# Access Compliance Report

## Public Rights-of-Way

| Intersection ID: 50942                  | Main Street: CEDAR_WALK_LN | Cross Street: DUNAVERTY_PL              | Location: NE           |
| ADA ID: 9747539E9EF6                    | Ramp Type: PerpDiag        | Initial Pass/Fail: Fail                 | Overall Compliance: No |

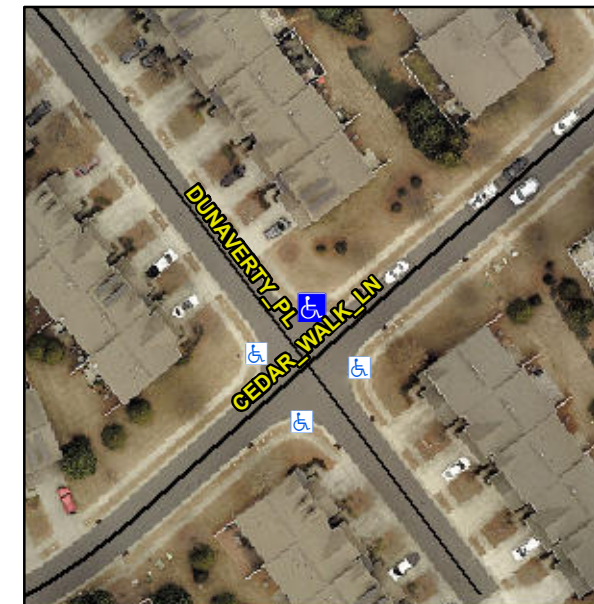
**Not Found, R304.5.1, R304.5.3**

| Compliance | Description           | Data  | Compliance | Description                 | Data  |
|------------|-----------------------|-------|------------|-----------------------------|-------|
| No         | Ramp Width (in)       | 47.5  | No         | Ramp XSlope (%)             | 9.4   |

**Remove & Replace Curb Ramp With Two New Directional Ramps or Equivalent.**
